City of Portland, Oregon
Bureau of Development Services
Land Use Services

NOTICE OF A TYPE Ix DECISION ON A PROPOSAL IN YOUR NEIGHBORHOOD

CASE FILE NUMBER: LU 16-131330 LDP

Proposal: The applicant proposes a two parcel land division of the 4,500 square foot, vacant site to create two parcels for development of attached houses. The proposal employs provisions of Subsection 33.110.240.E *Alternative Development Options*, which allows one extra unit of density when attached houses are proposed on a corner lot. Water service will be provided by existing utilities within N Hamlin Avenue. Sanitary sewer service will be

REVISIONS
 6/2/16
 CASE NO. LW 16-10333-000
 EXHIBIT C-1

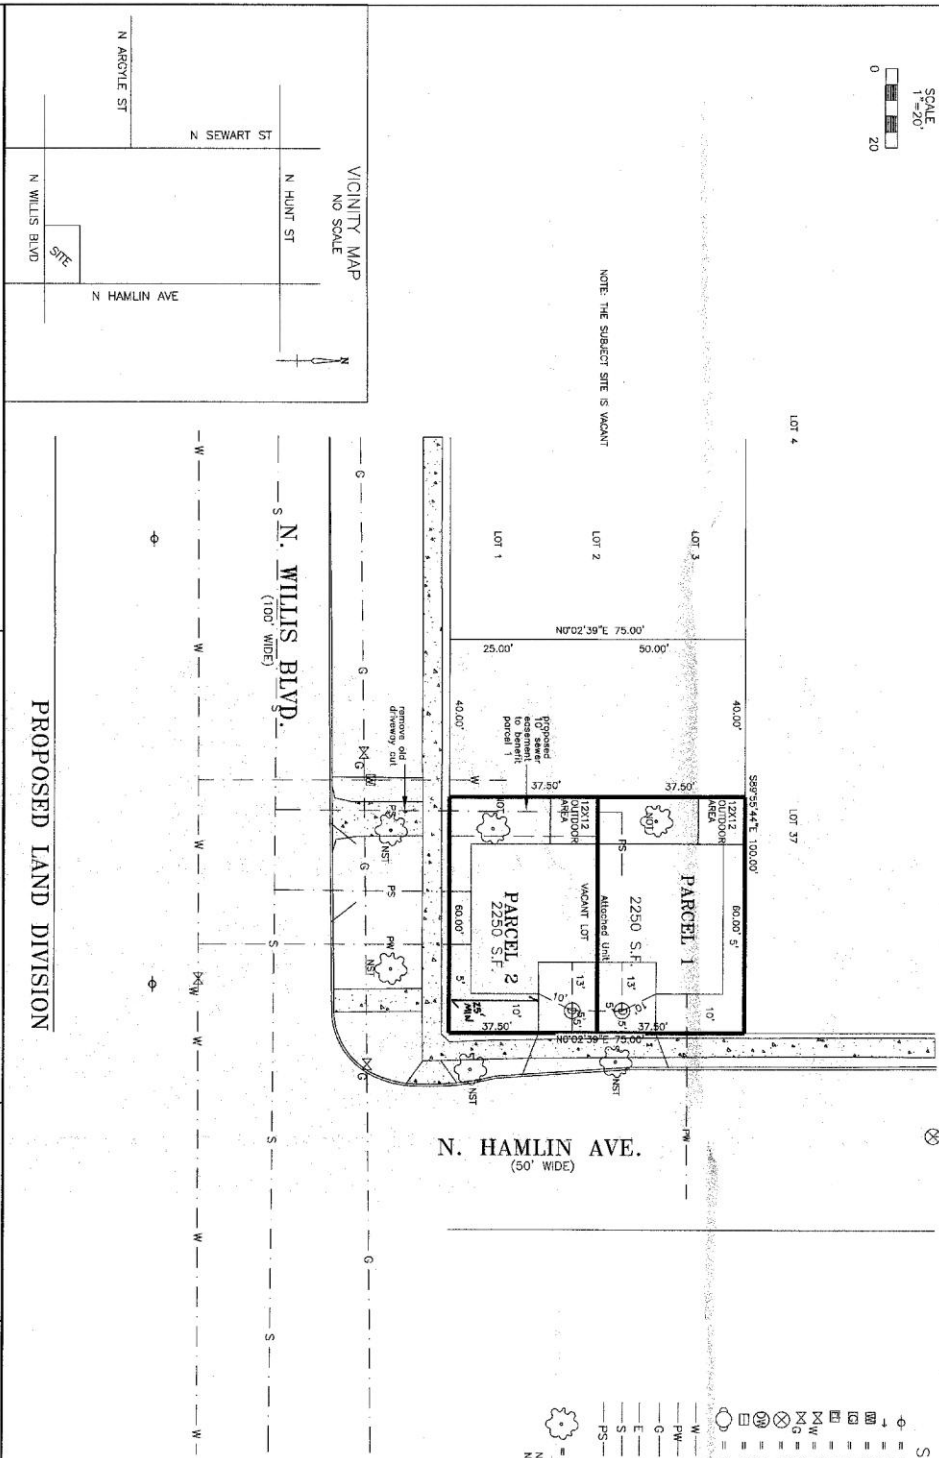
- A **Private Sanitary Sewer Easement** is required across the relevant portions of Parcel 2, for a sanitary sewer lateral connection that will serve Parcel 1.

The original site plan submitted with this partition (Exhibit A.1) proposed separate driveways to serve each parcel with a new curb-cut on N Hamlin to serve Parcel 1 and a new curb-cut on N Willis to serve Parcel 2. PBOT does not support this driveway configuration. For Neighborhood Collectors, such as N Willis, PBOT requires that vehicles be able to exit the site in a forward motion to ensure safe vehicle movements. The size and configuration of Parcel 2 does not appear that it will permit the lot to be designed to allow forward motion egress. Additionally, the proposed driveway location on N Willis is closer to the intersection and the existing marked crosswalk than the curb-cut that served the prior home on this site. This proposed location creates numerous potential vehicle/pedestrian conflict points.

Accordingly, as a condition of Building Permit approval, PBOT will require that the proposed attached dwellings be developed with a shared driveway on N Hamlin. The

applicant may seek formal approval of a Driveway Design Exception to allow separate driveways on N Hamlin. Vehicle access to Parcel 2 will not be permitted via N Willis.

33.653.020 & .030 Stormwater Management criteria and standards – See Exhibits E.1
No stormwater tract is proposed or required. Therefore, criterion A is not applicable. The applicant has proposed the following stormwater management methods for Parcels 1 and 2: Stormwater from these lots will be directed to individual drywells that will treat the water and slowly infiltrate it into the ground. Each of these lots has sufficient area for a stormwater facility that can be adequately sized and located to meet setback standards, and accommodate water from a reasonably-sized home. BES has indicated conceptual approval of the drywells, and has requested a supplemental survey prior to final plat approval showing the final location of stormwater facilities. With a condition of approval, this criterion is met.

1. A private sanitary sewer easement, for the benefit of Parcel 1, shall be shown and labeled over the relevant portions of Parcel 2.
2. A recording block for each of the legal documents such as maintenance agreement(s), acknowledgement of special land use conditions, or Declarations of Covenants, Conditions, and Restrictions (CC&Rs) as required by Condition C.1 below. The recording block(s) shall, at a minimum, include language substantially similar to the following example: "A Declaration of Maintenance Agreement for a sanitary sewer easement has been recorded as document no. _____, Multnomah County Deed Records."
3. To meet the Solar Access requirements of section 33.639, Parcel 1 must be wider than Parcel 2. The plat must be revised to meet these requirements in accordance with section 33.663.310.

1. Prior to Final Plat approval, the applicant shall close the existing curb-cut on N Willis under a Minor Improvement Permit from the Bureau of Transportation.

1. Parcels 1 and 2 may only be developed with attached houses meeting the development standards of Section 33.110.240.E.
2. Vehicle access to Parcels 1 and 2 must be from N Hamlin Avenue. Separate driveways will only be permitted with an approved Driveway Design Exception.
3. The applicant must meet the Fire Bureau requirements for addressing and aerial fire department access. Aerial access applies to buildings that exceed 30 feet in height from the fire access as measured to the bottom of the eave of the structure or the top of the parapet for a flat roof.
4. The applicant must meet the requirements of Urban Forestry for street tree planting in the existing planter strips adjacent to Parcels 1 and 2
